SERVICE BULLETIN CHANGE NOTICE

S.B. No. A320-21-1023 REV.

MOD. No. 21688P01857

TITLE : AIR CONDITIONING - IMPROVED ADIRU DRAINAGE.

Drilling of 2 Drainage Holes in Lower Plate of ADIRUs Support
Figure 1

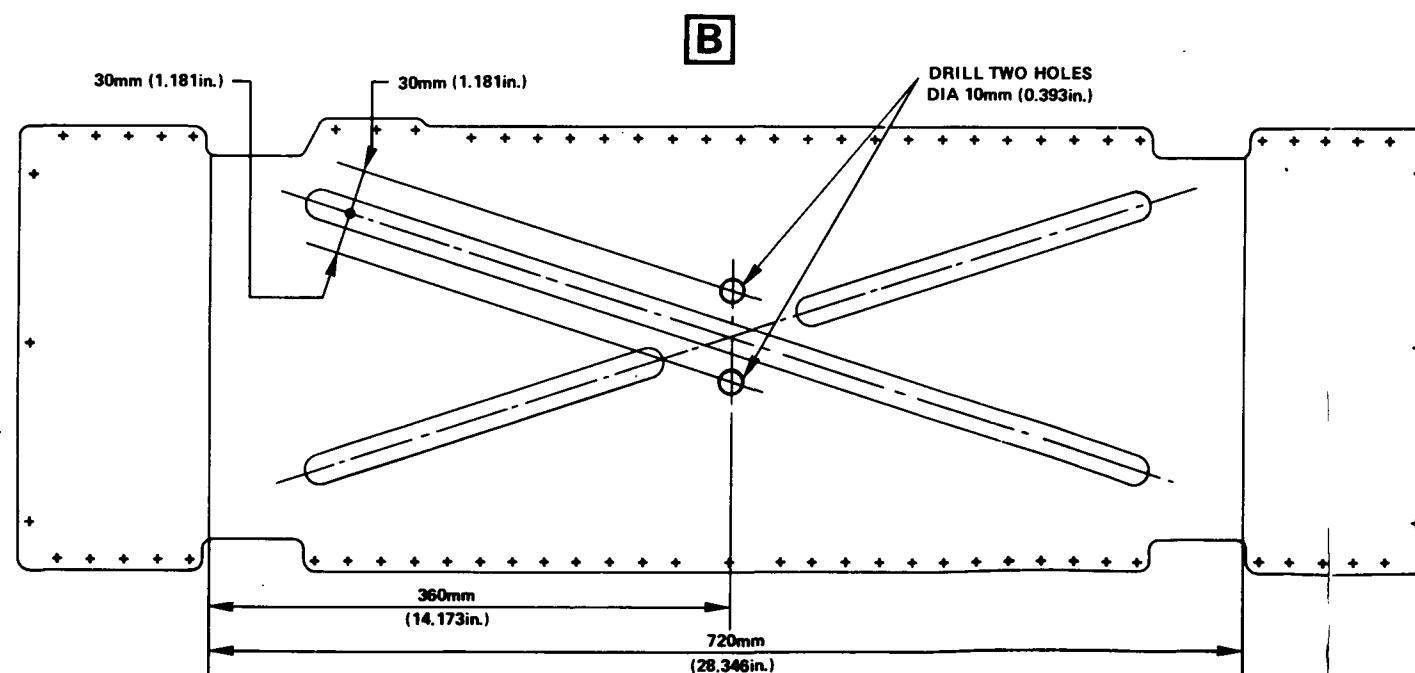
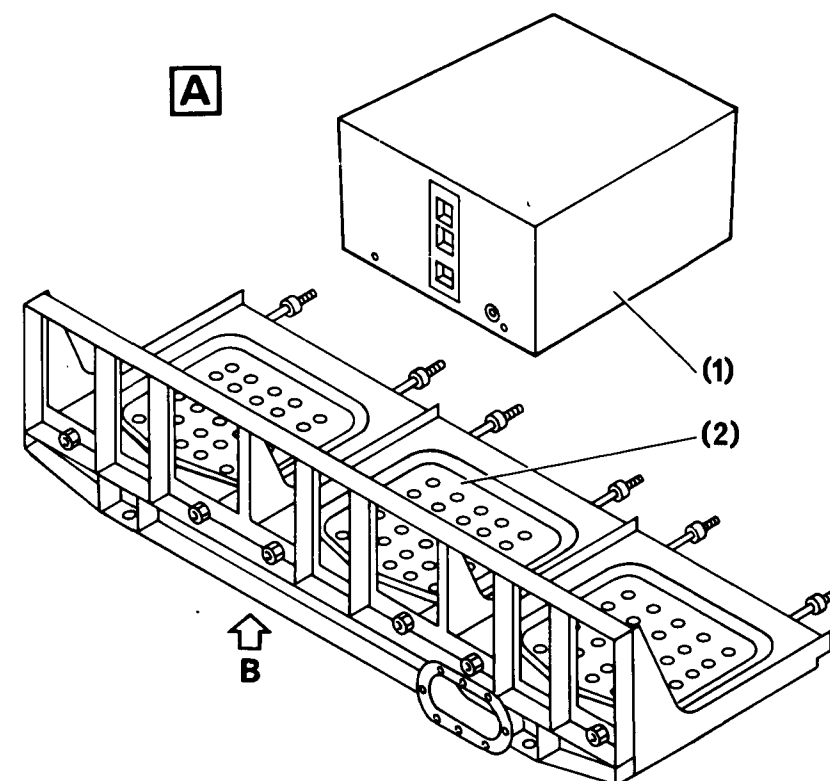
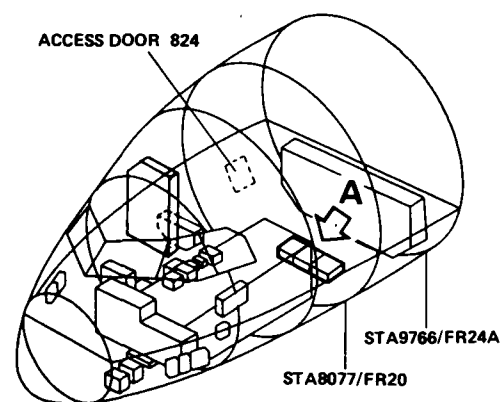
Drill 2 drainage holes in the lower plate of the ADIRUs support.

Refer to Figure 1

- (2) Drill 2 holes in the lower plate.
 - (a) Mark and drill 2 holes 10 mm (0.39 in.) dia.
 - (b) Clean the work area with Material No. 11-003 (Ref. CLM).
 - (c) After the drilling, deburr the holes and renew the protective finish (Ref. AMM 51-23-11) with Materials No. 13-002, 16-001 and 16-002 (Ref. CML).

NOTE : If necessary, to allow the swarf to be collected after drilling the holes remove the ADIRU's 1FP1 and 1FP2.

D9241000620000 becomes D9241000620200
D9241000000000 becomes D9241000000100
